CITY OF FRANKLIN
PLAN COMMISSION MEETING*
FRANKLIN CITY HALL COUNCIL CHAMBERS
9229 W. LOOMIS ROAD, FRANKLIN, WISCONSIN
AGENDA
THURSDAY, MAY 5, 2022, 7:00 P.M.

1. **BEAR DEVELOPMENT, LLC RISE COMMERCIAL DISTRICT WAREHOUSE/OFFICE MULTI-TENANT INDUSTRIAL DEVELOPMENT AND ASSOCIATED PARKING WITHIN RYAN MEADOWS SUBDIVISION.** Natural Resource Features Special Exception application by Stephen R. Mills, President of Bear Development, LLC (Loomis & Ryan, Inc. and Gurjit Singh and Gurmit Kaur, property owners) and Site Plan application by Jim R. Sapp, President of RISE Commercial District (Loomis & Ryan, Inc., property owner), as follows:
Natural Resource Features Special Exception: for the purpose of impacting approximately 14,939 square feet of wetland buffer (11,558 square feet of temporary impacts (grading and site disturbance) and 3,381 square feet of permanent impacts (paving and partial locations of five of the proposed buildings) and approximately 13,416 square feet of wetland setback (228 square feet of temporary impacts (grading and site disturbance) and 13,188 square feet of permanent impacts (paving and partial locations of five of the proposed buildings), with proposed impacts

SHEET C-3
C-24

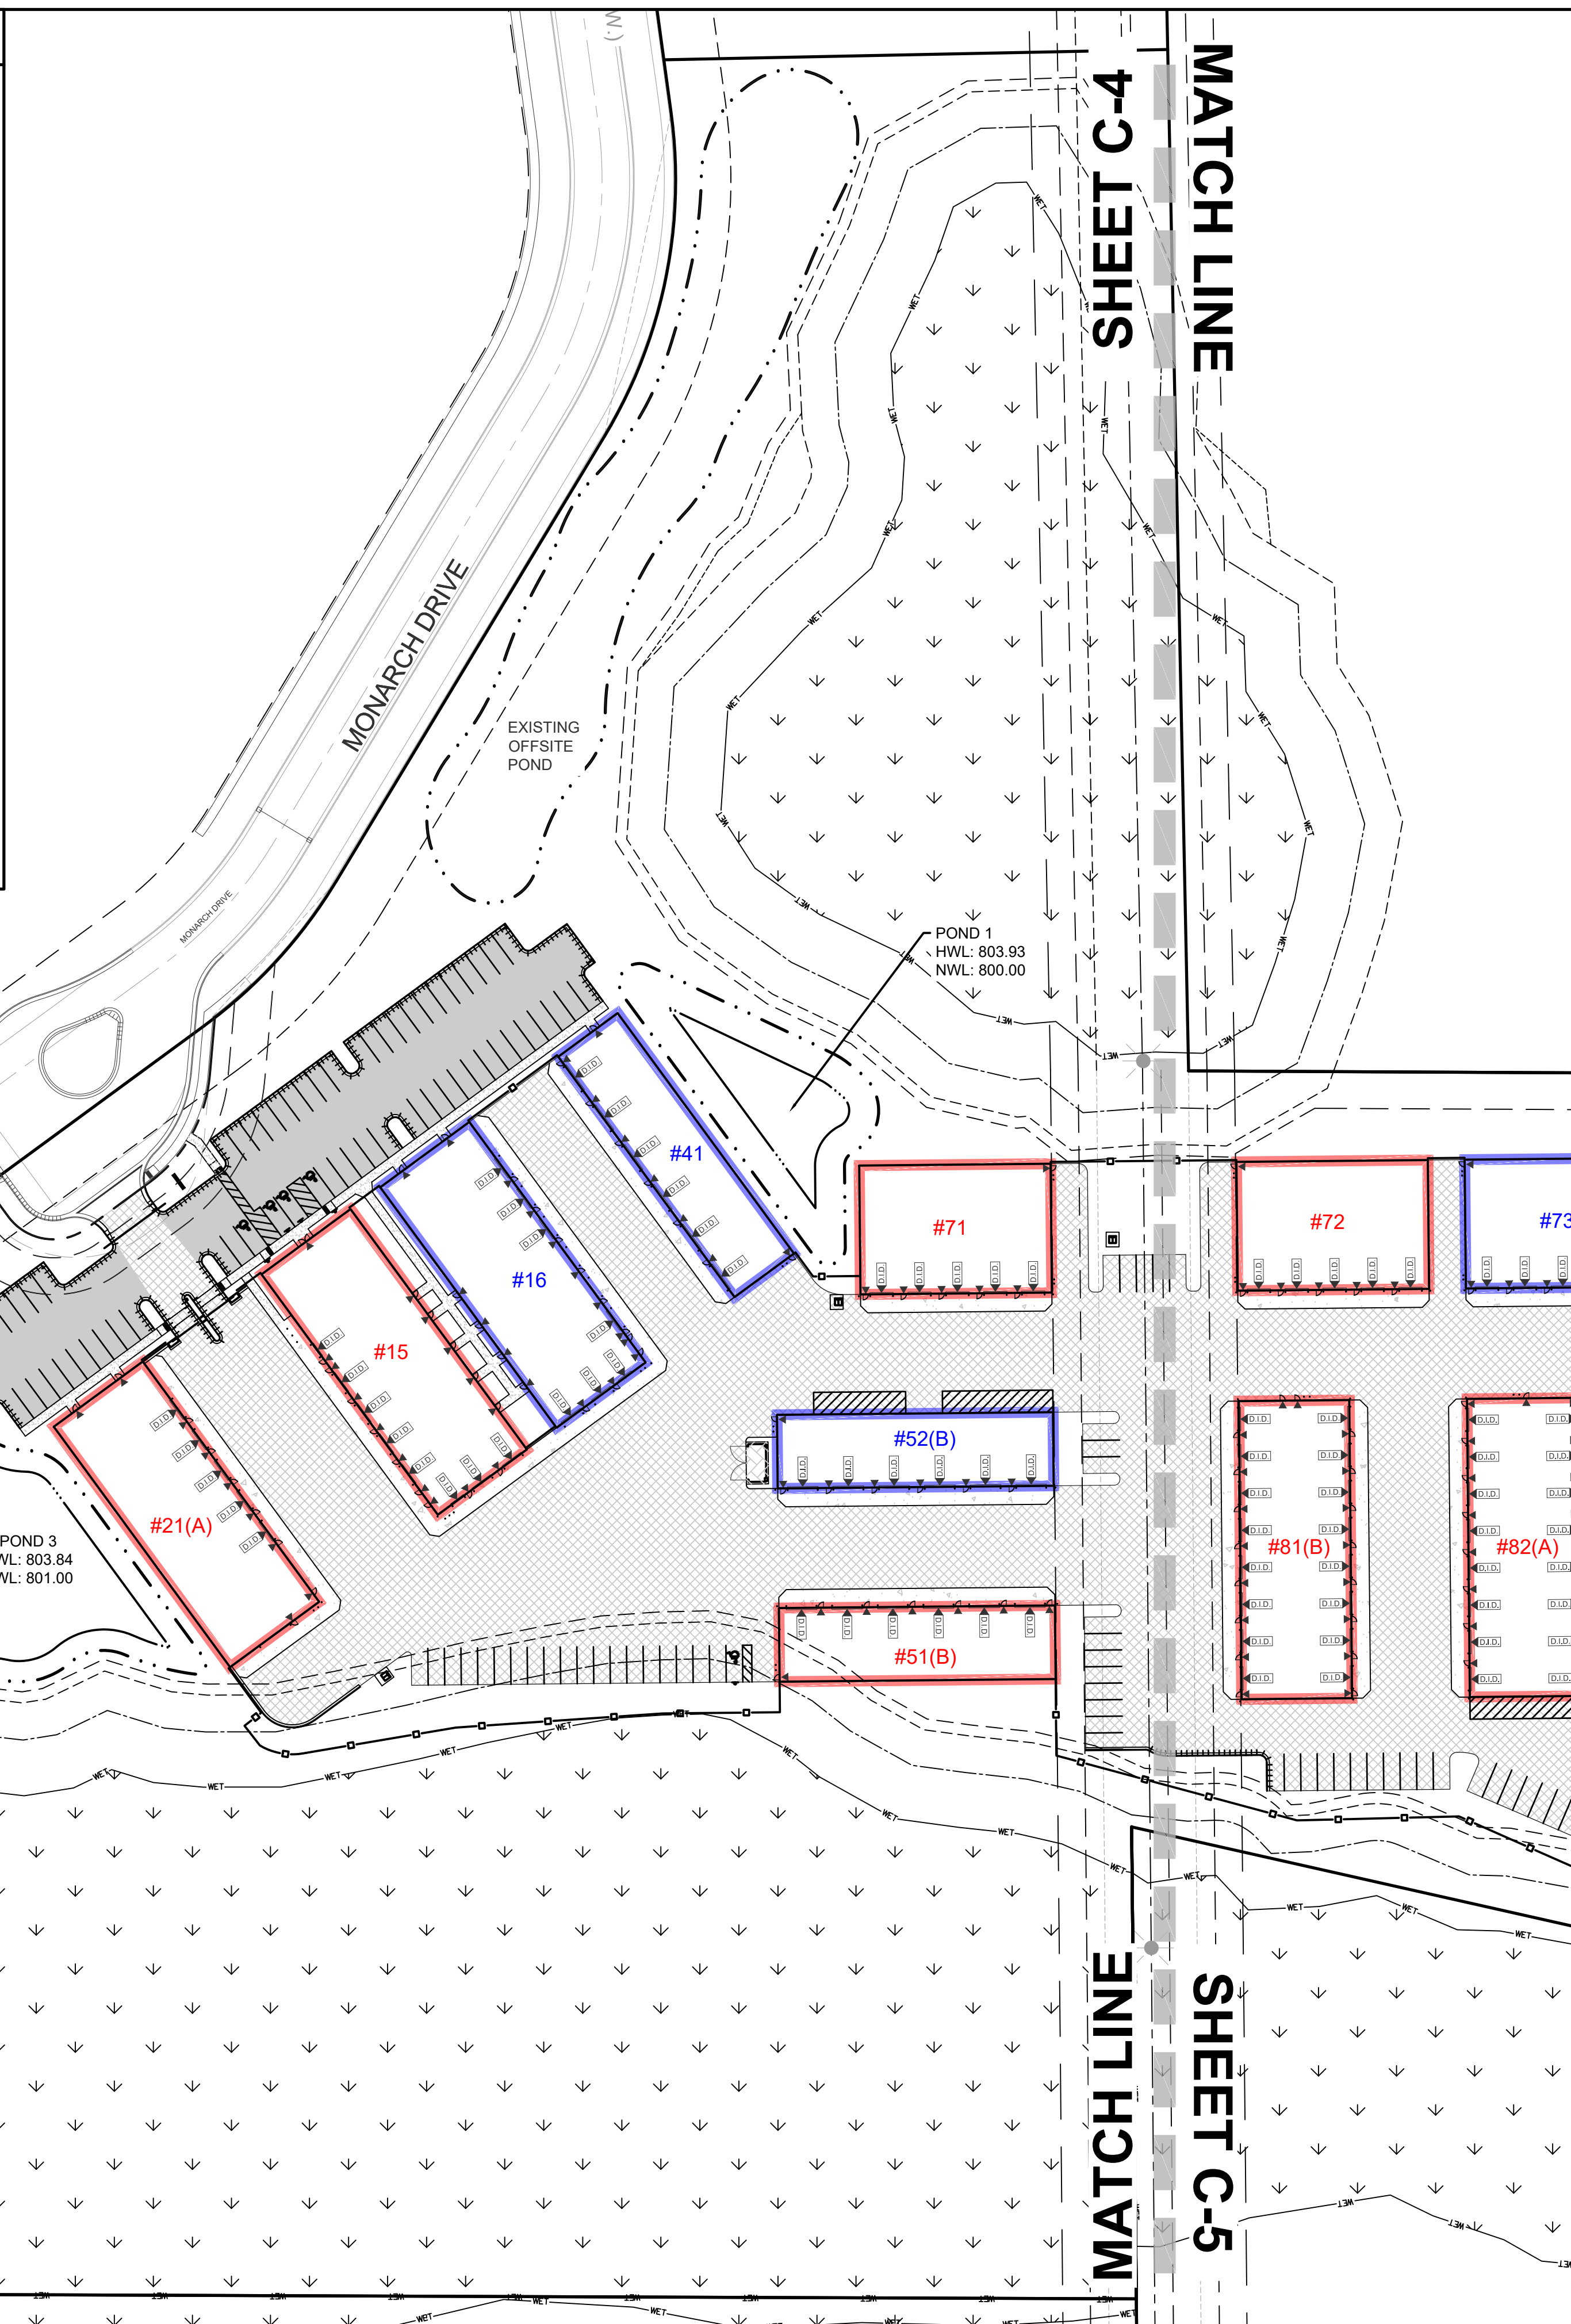
E. “Scale and Site Size. The scale of drawing and the size of the site (in square feet or acres) noted on the Site Plan”. Please update the base site area of 23.08 acres (Sheet C-3, site data), and associated ratios such as the Landscape Surface Ratio. Per recently approved certified survey map, the site area should be 22.93 acres.

Parking calculations have been provided in the Site Data Table on Sheet C-3. Total required parking for the intended uses is 117 spaces.
